Manual on Uniform Traffic Control Devices

Oregon Supplement to the 2009 Edition

Including Revision 1 dated December 2020

Adopted December 2011

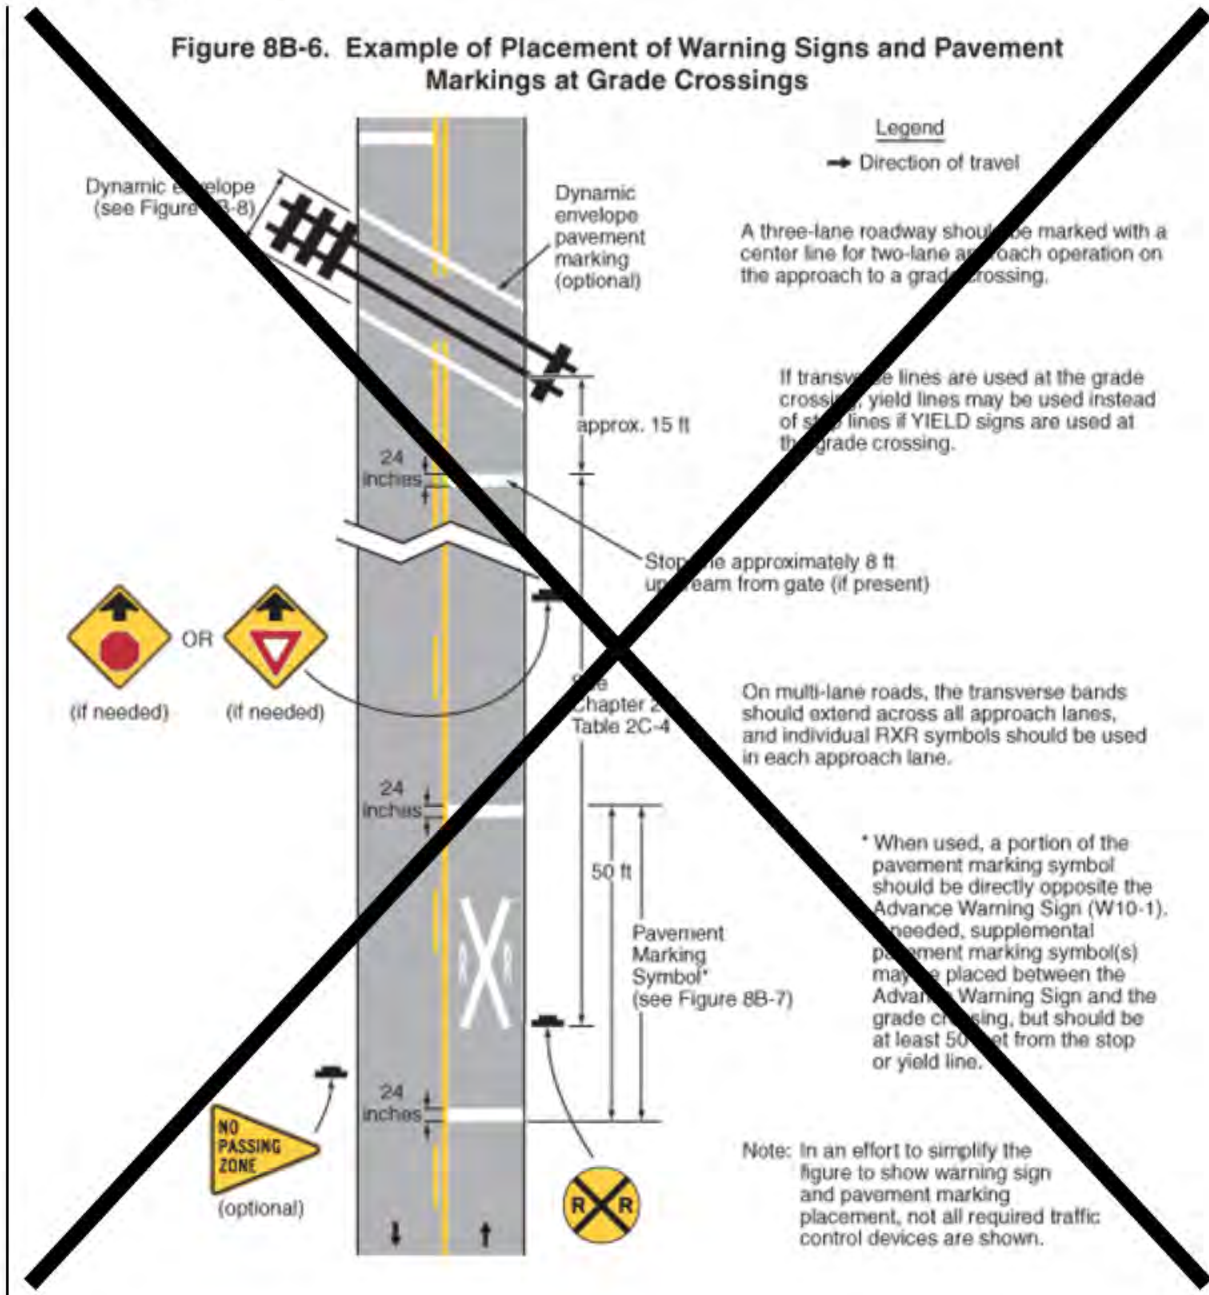
If a yield line is used, it should be a transverse line (see Figure 3B-16) at a right angle to the traveled way and should be placed no closer than ~~15~~ 12 feet in advance of the nearest rail (see Figure 8B-7).

Figure 8B-6(OR). Example of Placement of Warning Signs and Pavement Markings at Grade Crossings

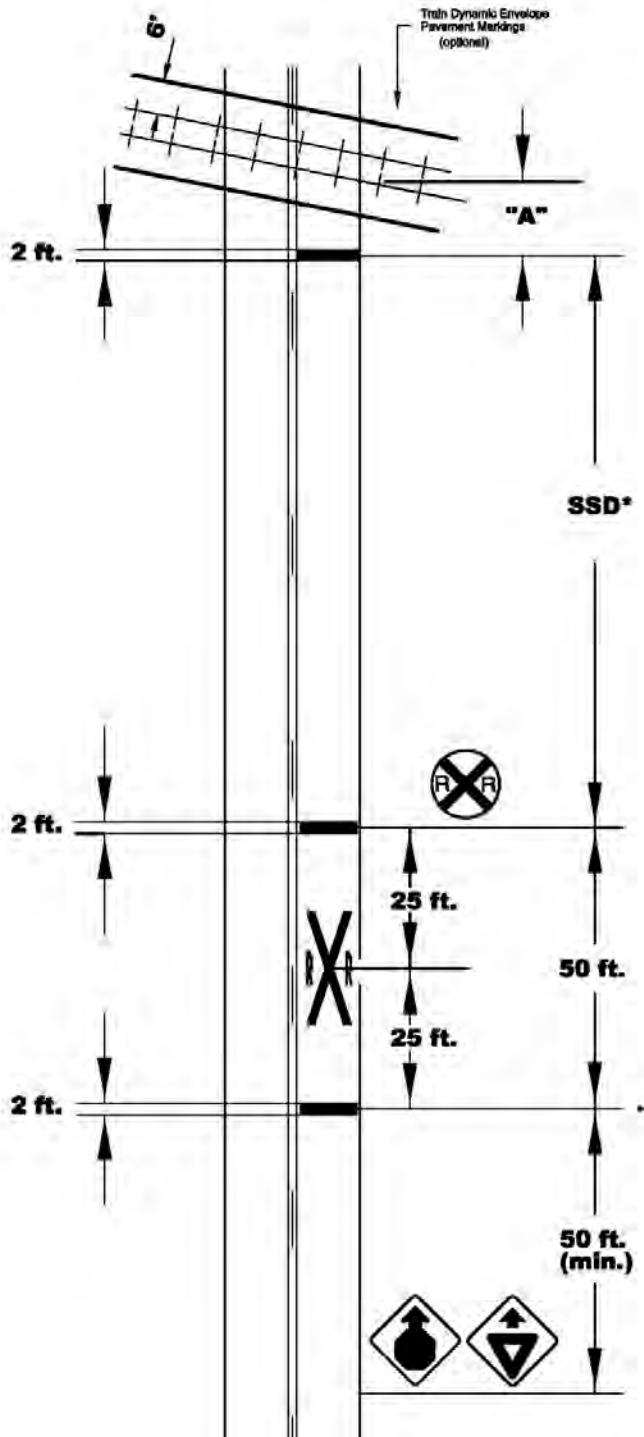
[Delete Figure 8B-6:]

[Insert Figure 8B-6(OR):]

The placement of the Highway-Rail Grade Crossing Advance Warning (W10-1) sign shall be in accordance with Figure 8B-6 (OR) and Table 1 of OAR 741-100-0020~~Section 2C.05 and Table 2C-4.~~

A three-lane roadway should be marked with a Centerline for two-lane approach operation on the approach to a crossing.

Figure 9B-4(OR). Guide Signs and Plaques for Bicycle Facilities

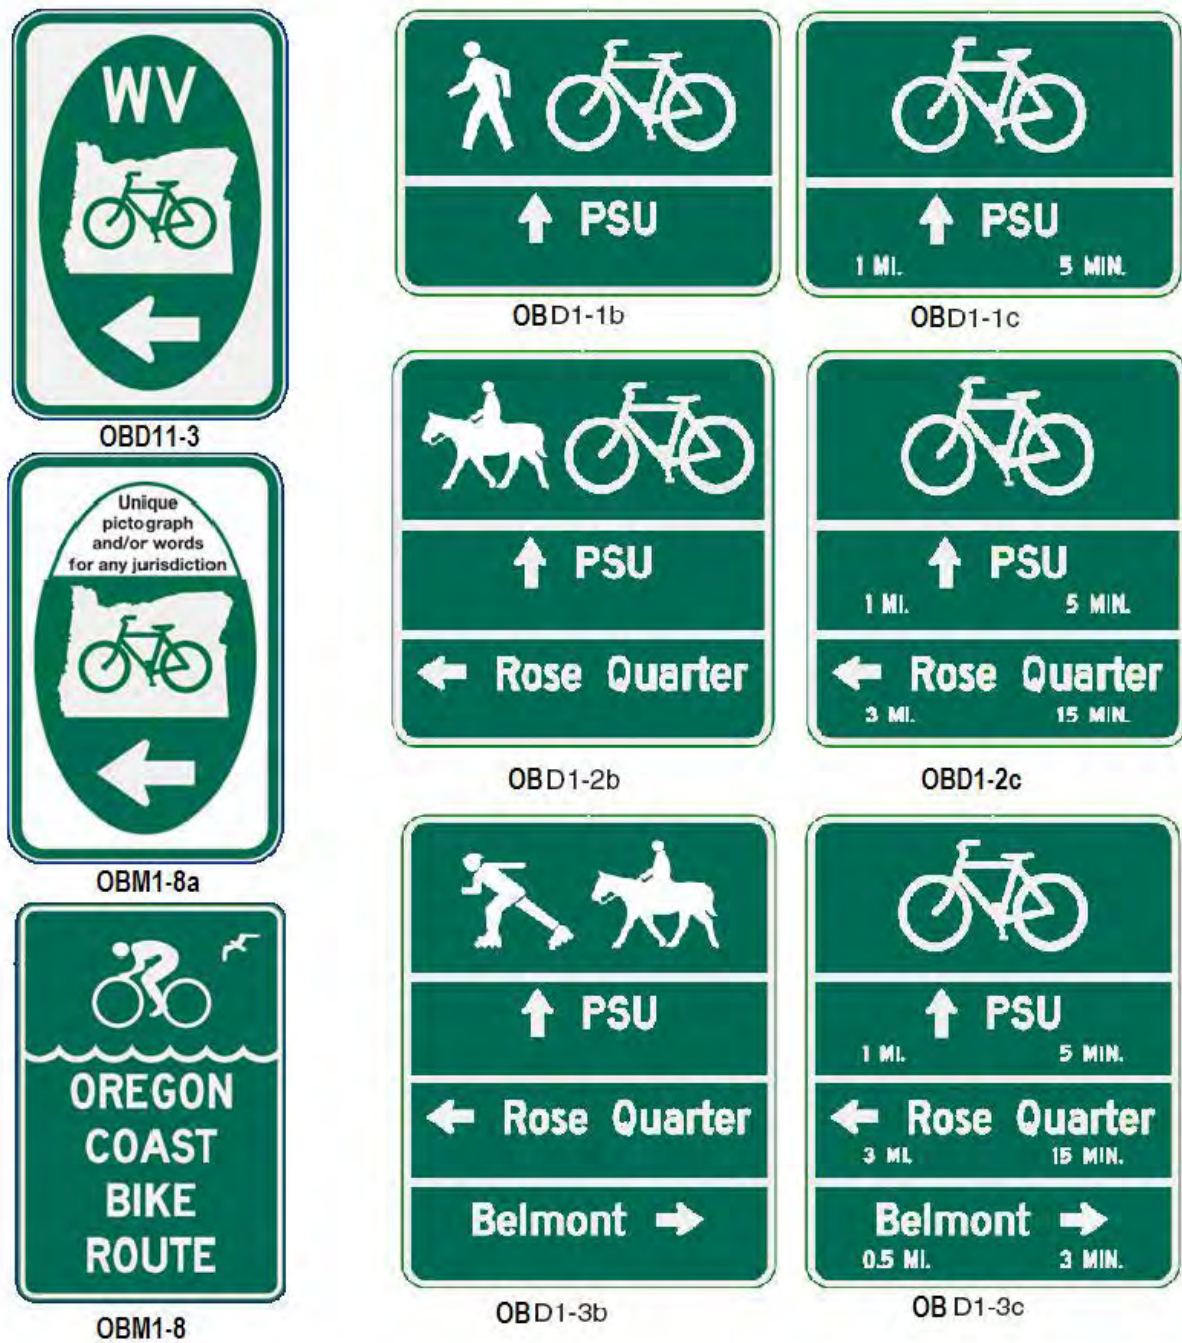
[Insert Figure 9B-4(OR):]

~~Bike Route~~Bicycle Guide signs ~~(D11-1) signs~~ (see Figure 9B-4 and Figure 9B-4(OR)) may be provided along designated bicycle routes to inform bicyclists of bicycle route direction changes and to confirm route direction, distance, and destination.

State and local agencies in Oregon developed design details for Bicycle Guide signs prior to their introduction in the MUTCD. Examples of these signs are shown in Figure 9B-4(OR) but are not exclusive of such examples.

State and local agencies in Oregon developed design details for Bicycle Route signs prior to their introduction in the MUTCD. Examples of these signs are shown in Figure 9B-4(OR) but are not exclusive of such examples.
